Cobb County Community Development Agency Zoning Division

Case # SLUP-7
Public Hearing Dates:
PC: 08-07-18

Proposed use: Suite Hotel

FINAL ZONING STAFF RECOMMENDATION: (Zoning staff member: Jason Campbell)

SLUP-7 (2018) Elevations and Floor Plans

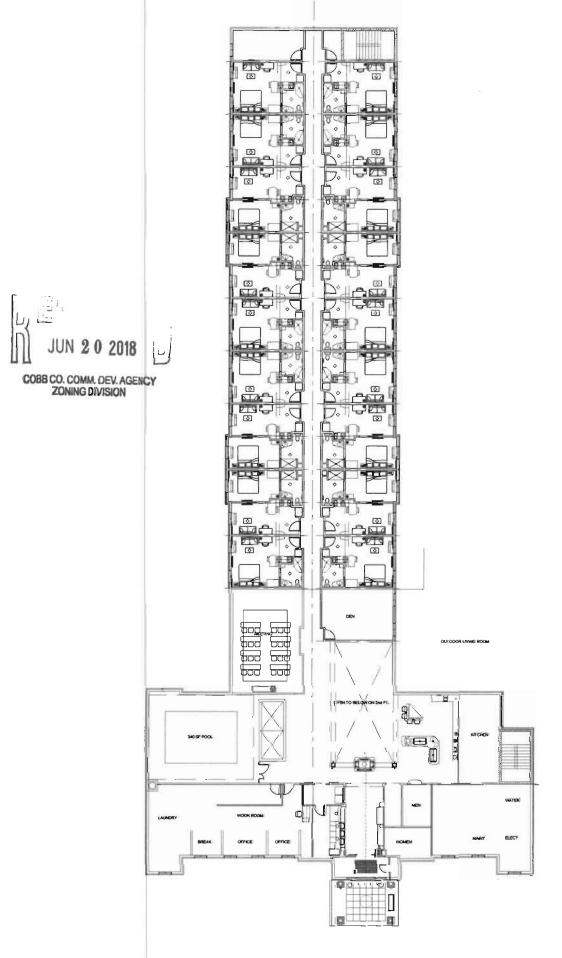
The applicant has provided sufficient information to allow a full consideration of all relevant factors, with the exception of the pitch of the roof of the five-story building. Suite hotels are supposed to have a minimum roof pitch of a four in twelve as defined by applicable building codes.
